PETITION NO. 85-54(A)
DATE SUBMITTED OCT 10,90
EXHIBIT NO. 67
SUPERSEDES EXH. NO. —

SITE PLAN - LAKE EXCAVATION - TYPE II
BABCOCK P.U.D.
PALM BEACH COUNTY, FLORIDA
LENNAR HOMES

Babcock Pud Site Plan - Lake Excavation TYPE II

TYP. LAKE CROSS SECTION

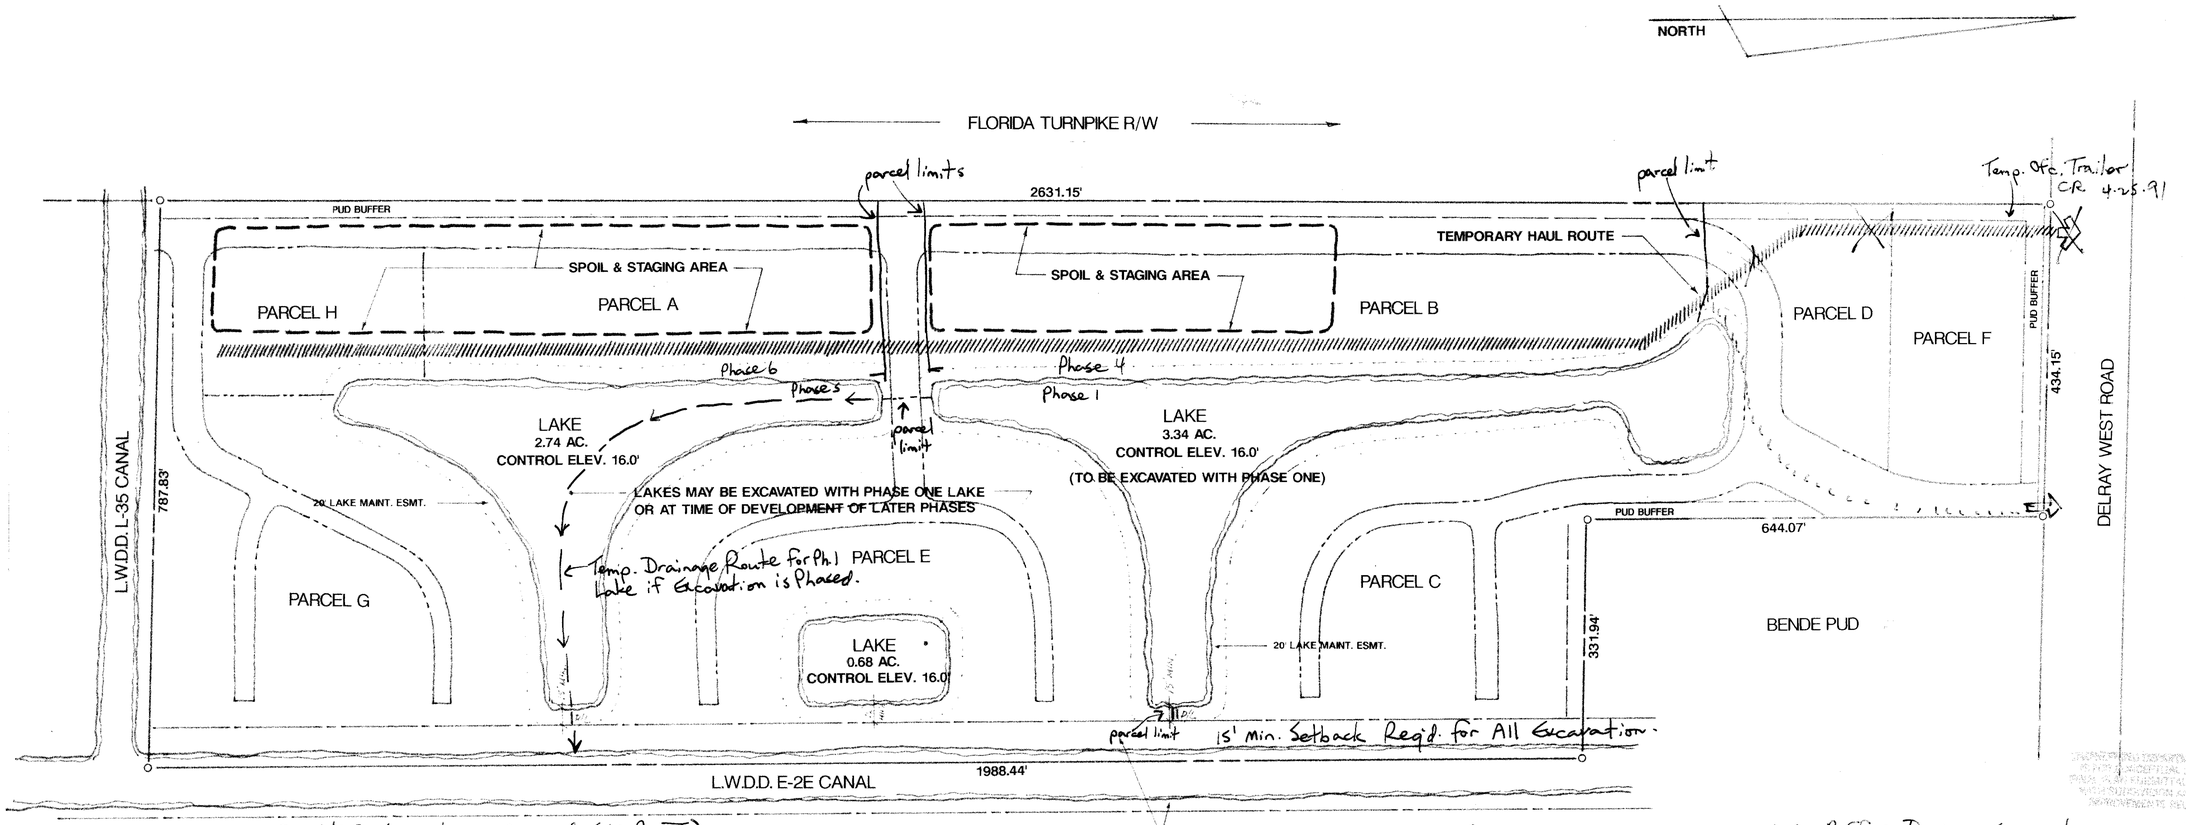
Reclamation:
Area to be Restored with Soil ≥ Quality of Excavated Topsoil.
Lake Slopes, Depths, Veg. Standards Pursuant to Section 500.3.
CR 11/15/90.

Export Due to Existing Elevations & Proposed Elevations.
